AGENDA

**CITY OF COLUMBIA TENNESSEE
BOARD OF ZONING APPEALS
STAFF REPORT**

**DOCKET/CASE/APPLICATION
NUMBER**
22-0200

Case #22-0183
Vulcan Quarry
TM 66 Parcels 20.25 & 20.26

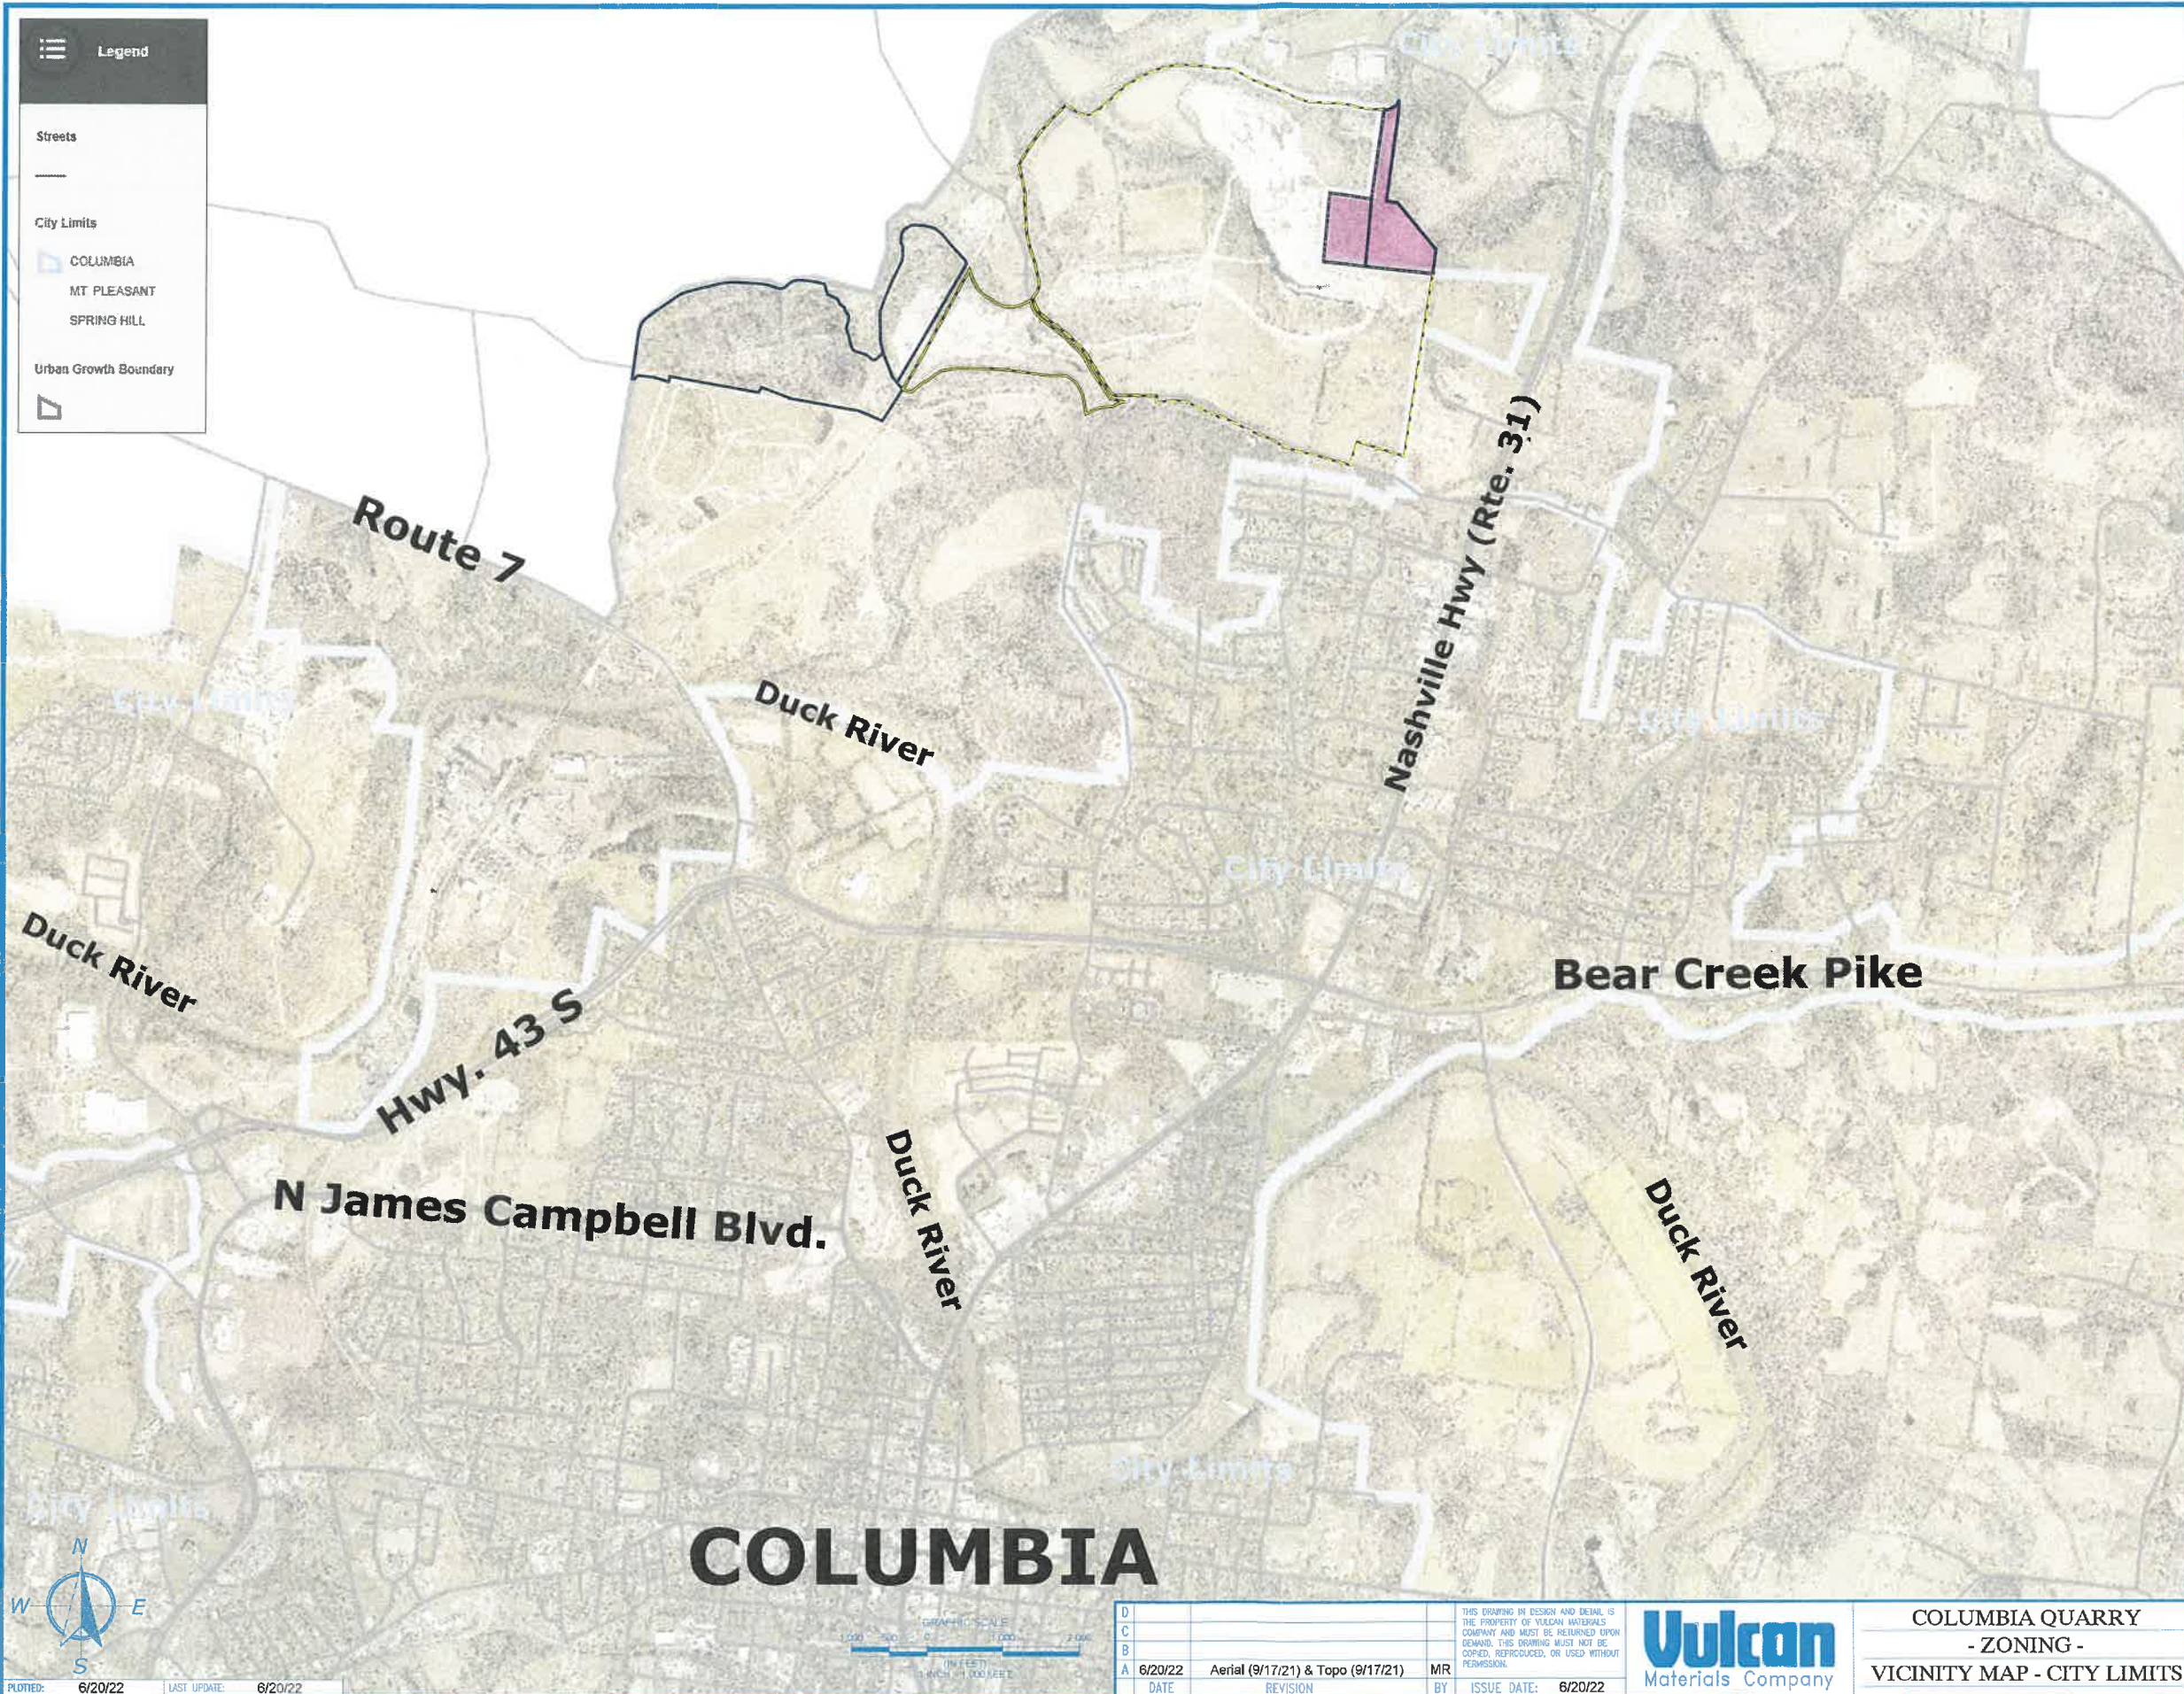
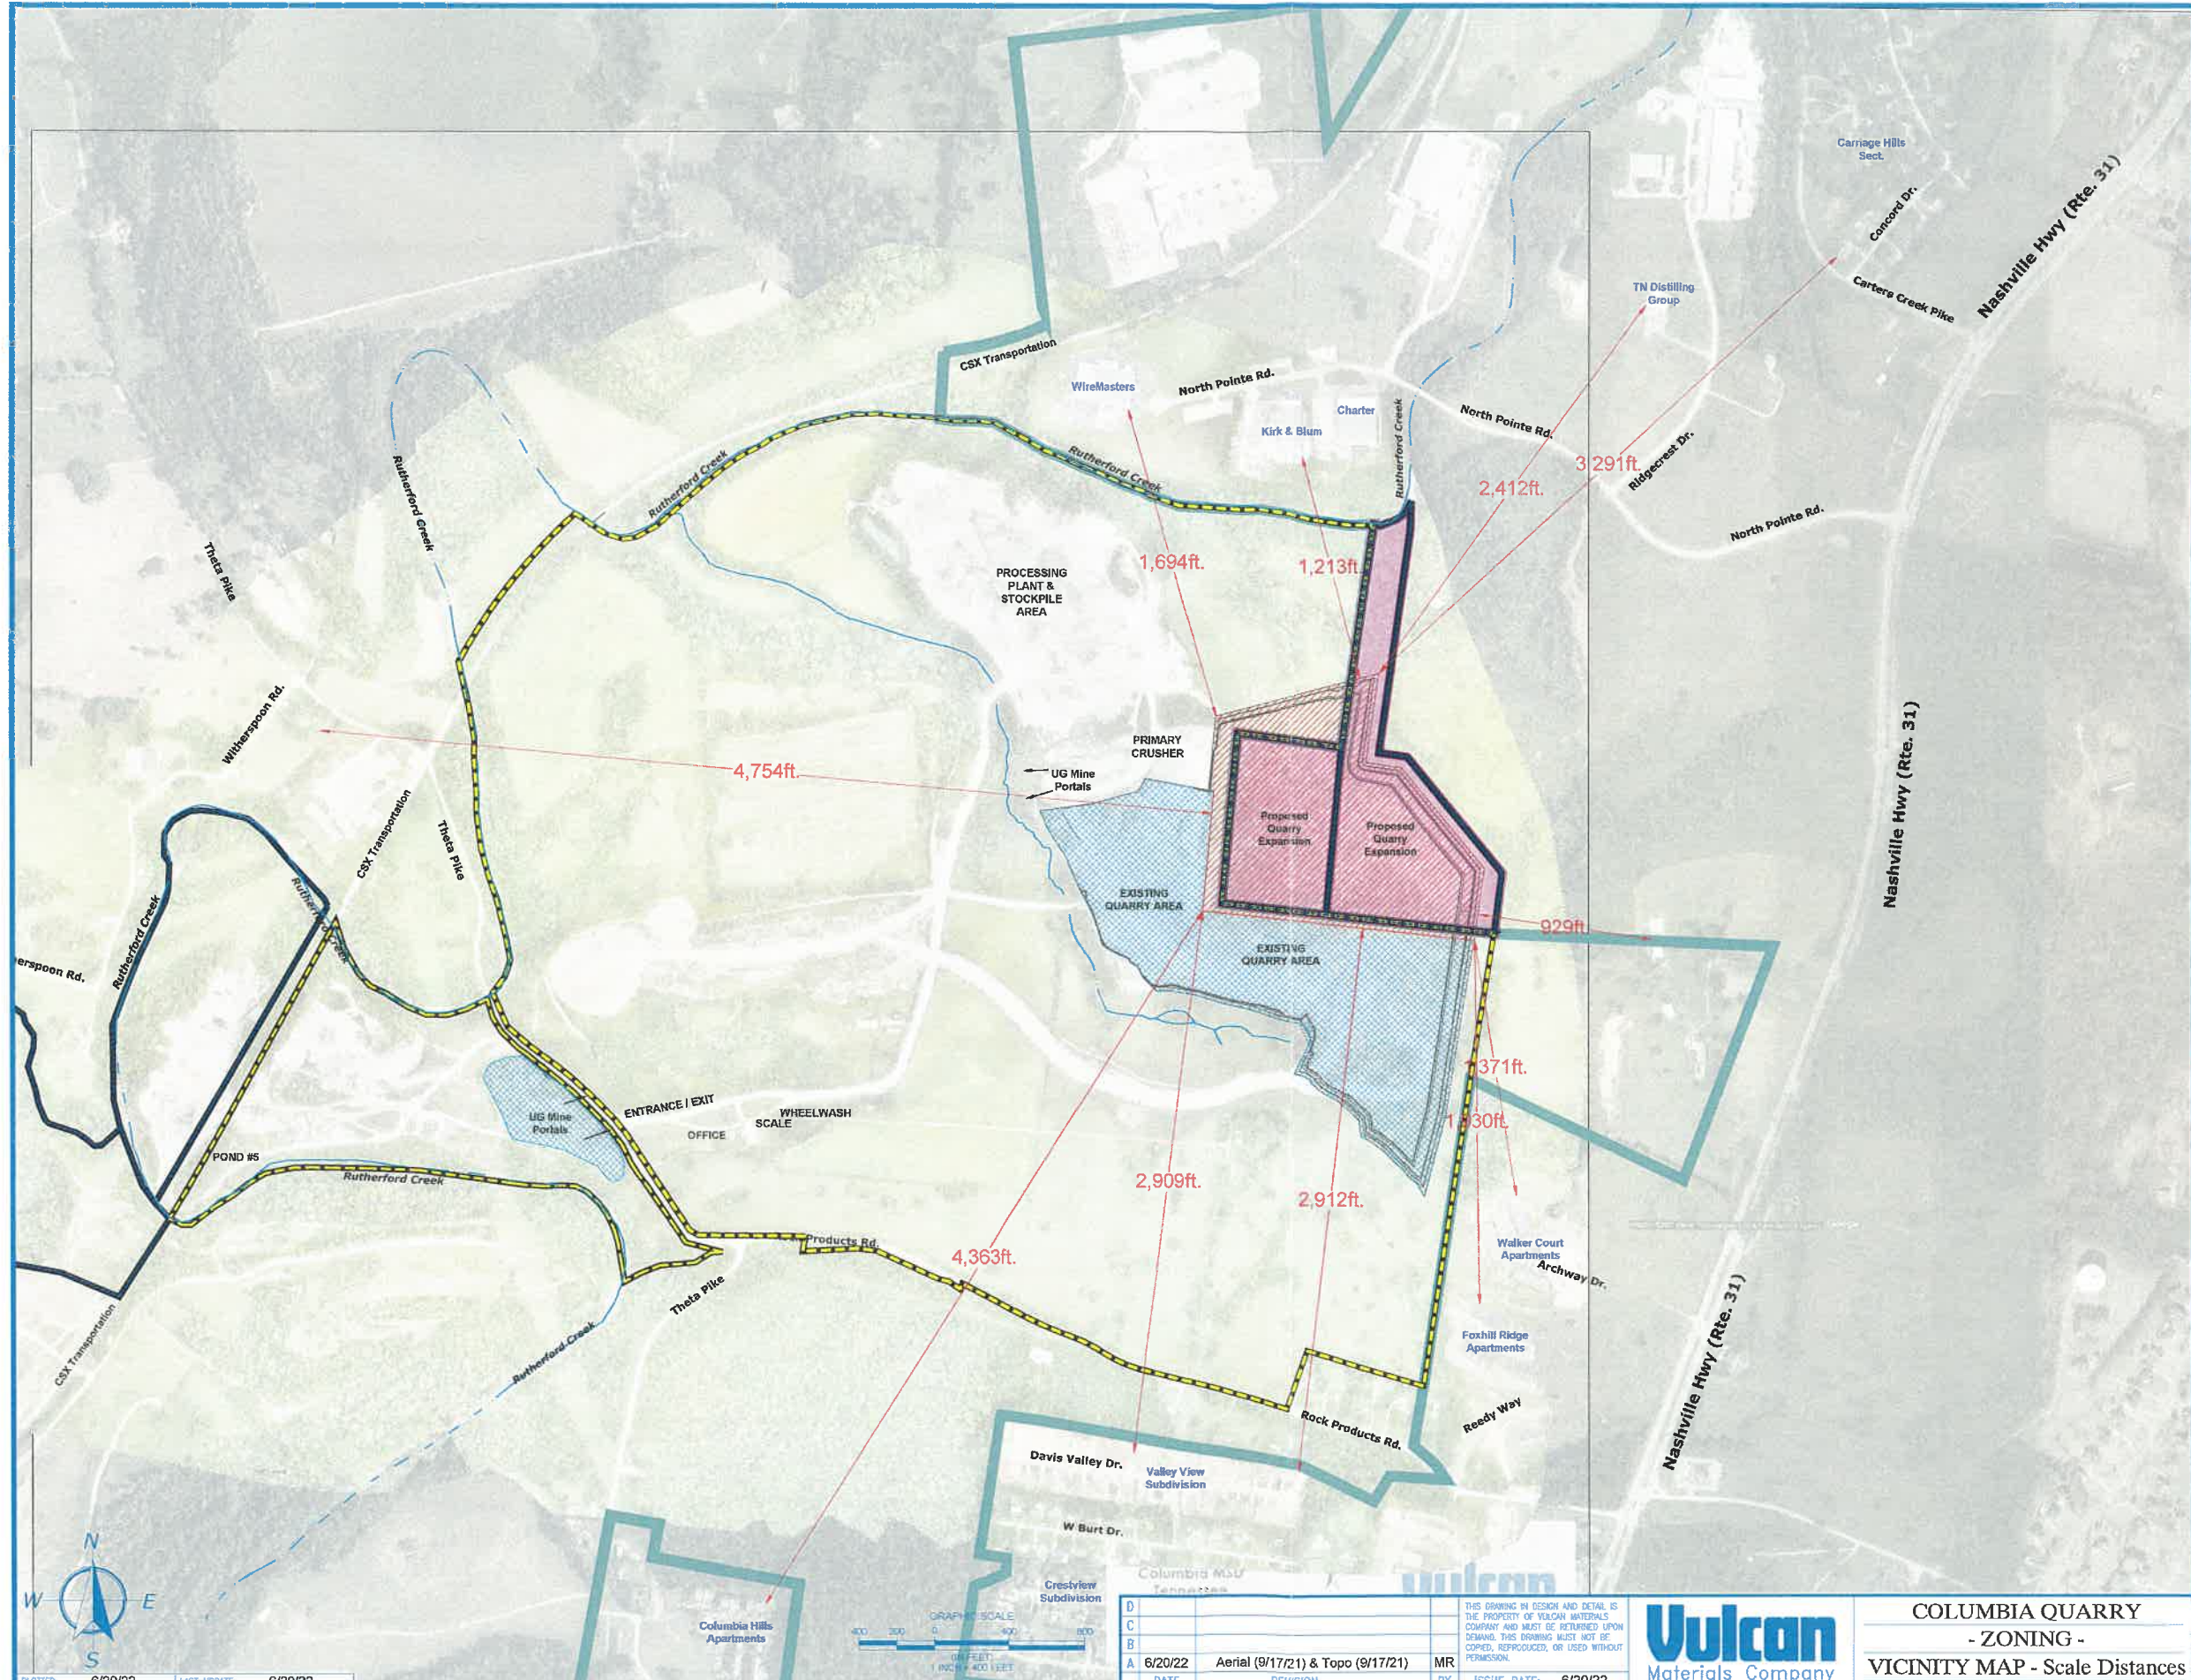
The Zoning Ordinance requires that every mining operation established in the city provide a plan for restoration of the site (8.3.1.C.1). The applicant's plan is illustrated at Exhibit I of the submittal and further described in the letter from the applicant's representative. Specifically, the applicant proposes to reduce the slope of the site using fill materials. The remaining "pit" will become a water feature and the site will be planted with native foliage. The Ordinance does not prescribe technical requirements for restoration of the site. The applicant's proposal appears to be in keeping with industry standard and the common practice for retiring exhausted quarries across Tennessee.

The Ordinance requires that a detailed site plan accompany every request to establish or expand a quarry operation (8.3.1.C.4). The applicant has provided a site plan comprised of Exhibits A through I of the submittal. The plan depicts the existing contours of the site and its vicinity at 2-foot intervals (8.3.1.C.4a and b), the method of drainage (8.3.1.C.4d), and the plan for restoring the site (8.3.1.C.1 and 8.3.1.C.4d).
